STP NUCLEAR OPERATING COMPANY  
Units 1 and 2  
Docket Nos. STN 50-498; STN 50-499  
Changes to Emergency Plan & Implementing Procedure

**Description of Changes**  
**0ERP01-ZV-IN05**  
**Site Evacuation, Rev. 6**

**0ERP01-ZV-IN05, Site Evacuation, Rev. 6**

## Plan A

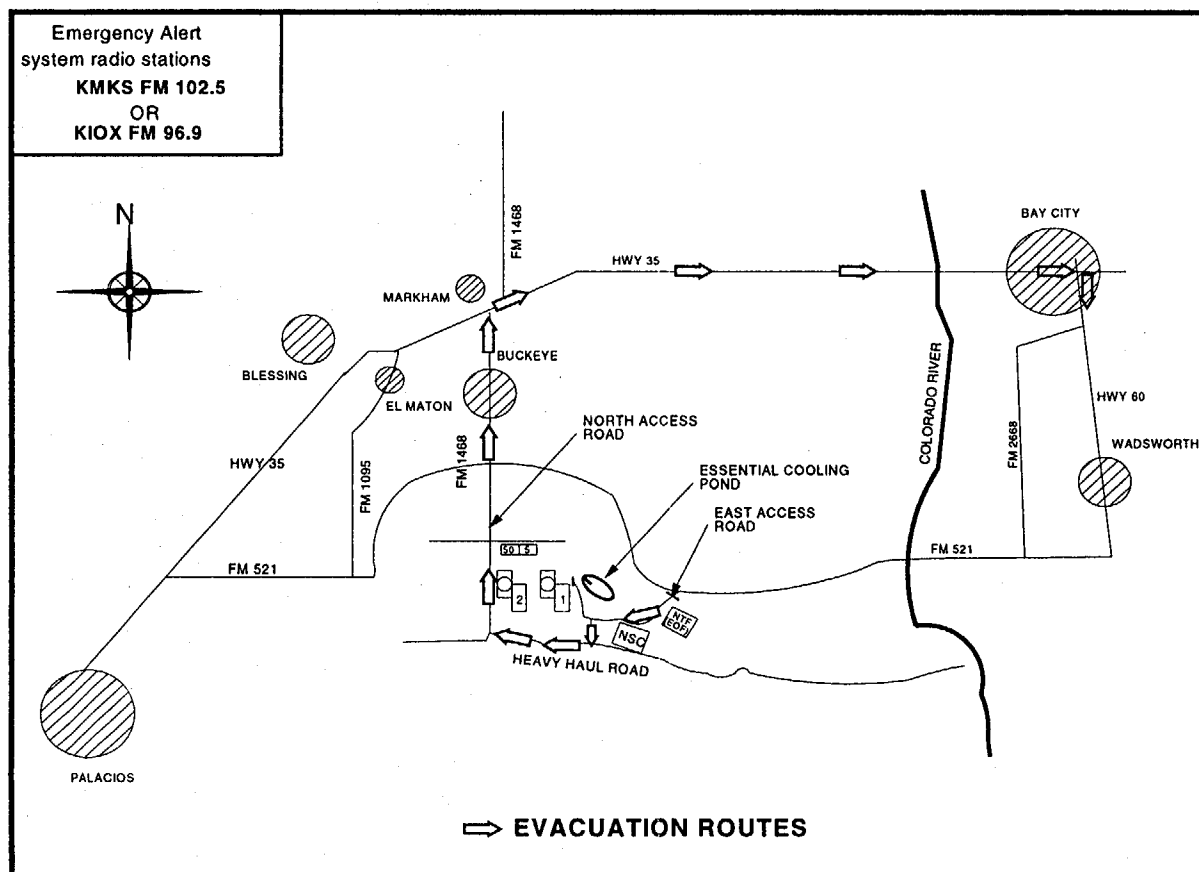
11.	Page 5, step 6.5, added "OPGP05-ZV-0004, Emergency Plan Implementing Procedure Users Guide."	Editorial "Reference"
12.	Addendum 1, page 6, added sector B, deleted the west access road gate, changed McAllister Junior High School to McAllister Middle School.	Changes due to closing the West Access Road and school name change.

## Plan B

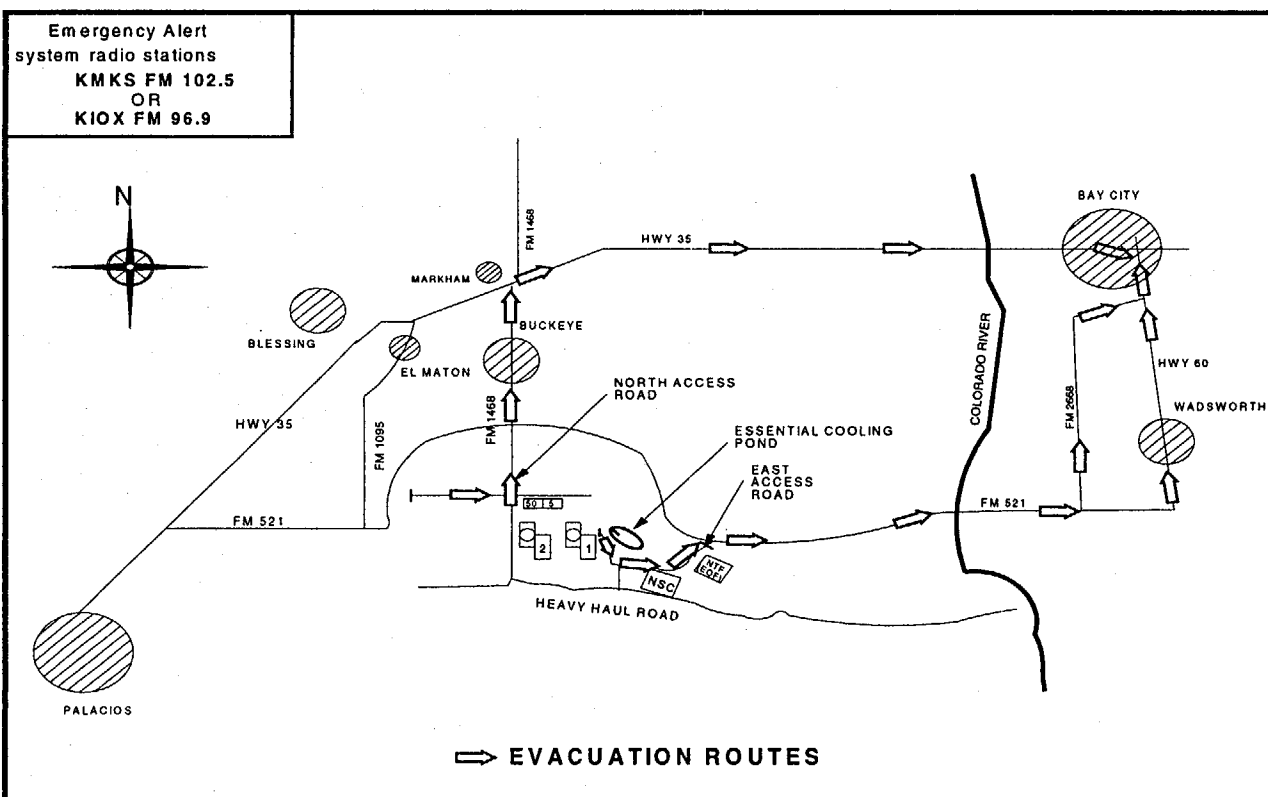
13.	Addendum 1, deleted old Plan B Map.	Changes due to closing the West Access Road.
14.	Addendum 1, page 7, changed from Plan C to B, deleted the west access road gate, changed McAllister Junior High School to McAllister Middle School.	Changes due to closing the West Access Road and school name change.

### Plan C

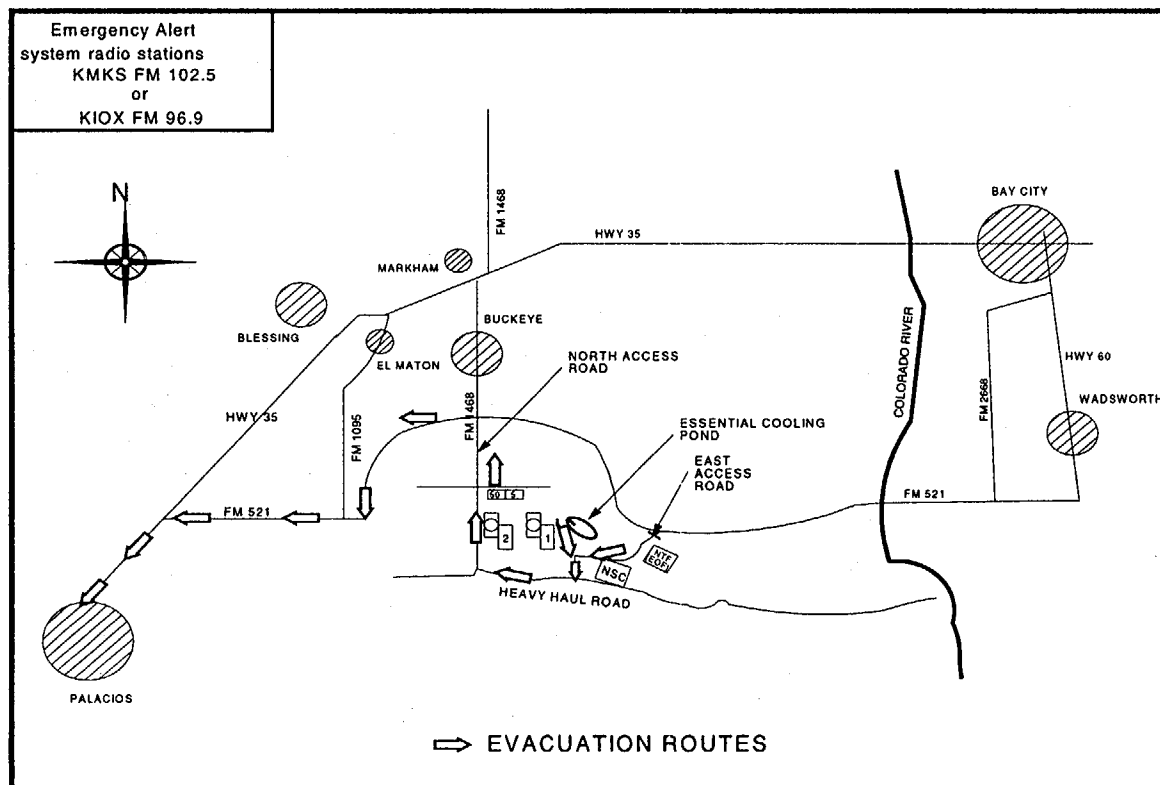
15.	Addendum 1, page 8, changed from Plan D to C, deleted the west access road gate, changed McAllister Junior High School to McAllister Middle School.	Changes due to closing the West Access Road and school name change.

### Plan D

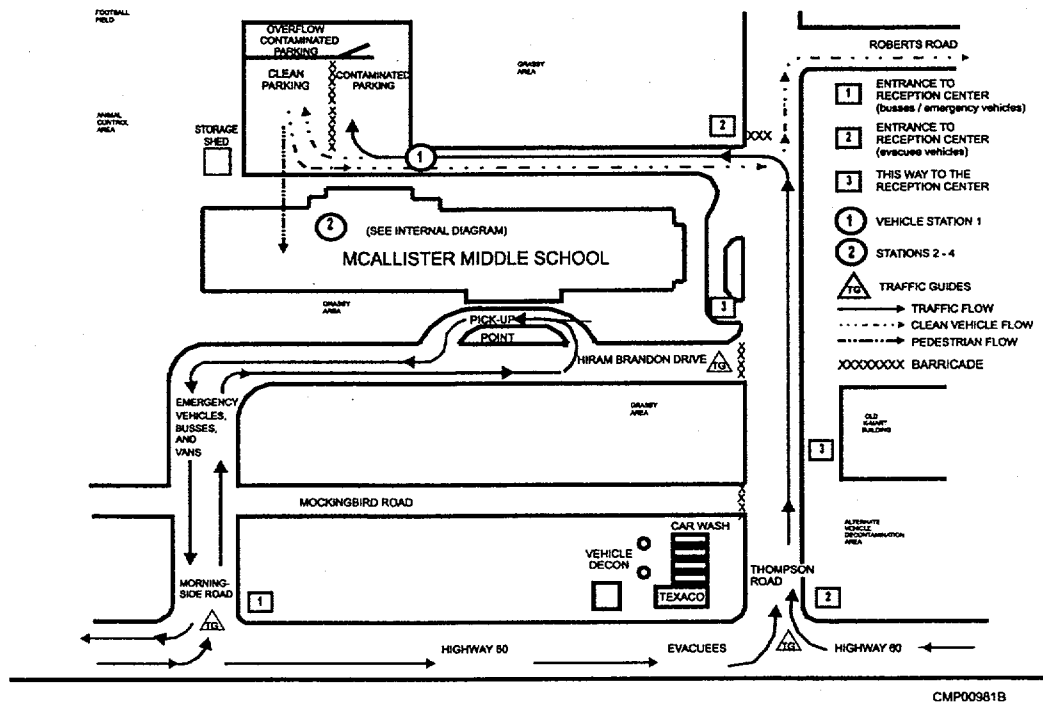
NO.	Change to Revision 5	Reason
16.	Addendum 1, page 9, changed from Plan E to D, deleted the west access road gate, diverted traffic from west to north access road, changed McAllister Junior High School to McAllister Middle School.	Changes due to closing the West Access Road and school name change.

<b>0ERP01-ZV-IN05</b>	<b>Rev. 6</b>	Page 10 of 20
<b>Site Evacuation</b>			
<b>Addendum 2</b>	<b>Reception Centers</b>		Page 1 of 1

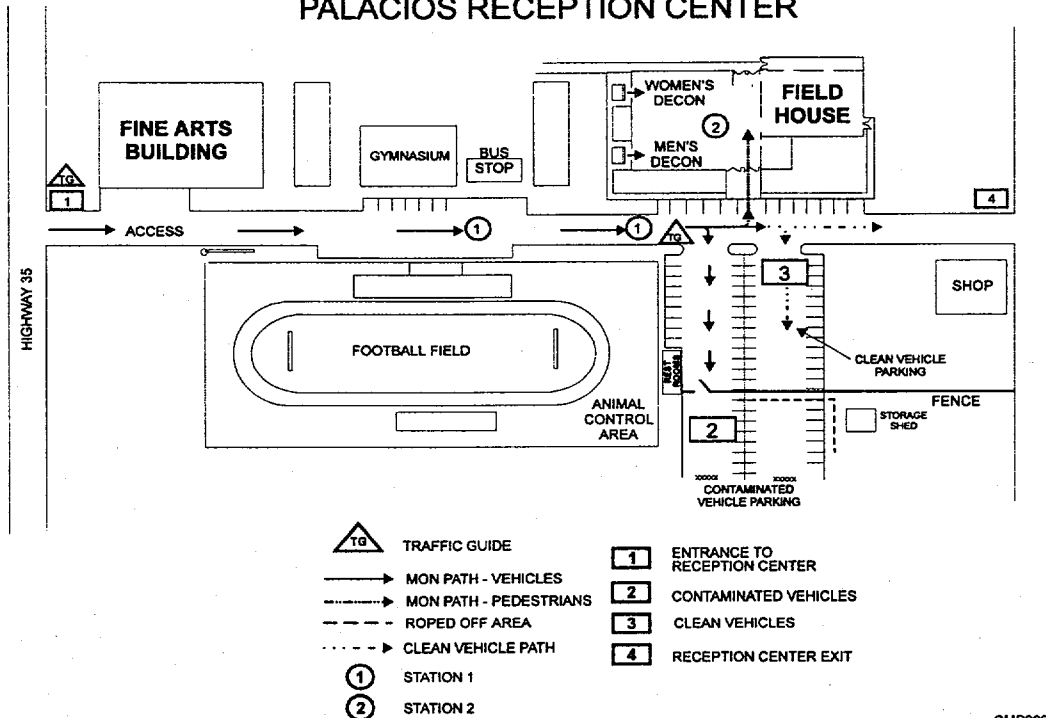
17.	Addendum 2, page 10, changed McAllister Junior High School to McAllister Middle School.	Name changed
18.	Data Sheet 1, page 11, changed from Assistant TSC Manager to Shift Supervisor.	Clarification, gives the SS specific direction and a checklist. The Assistant TSC Manager is directed to use Data Sheet 2.
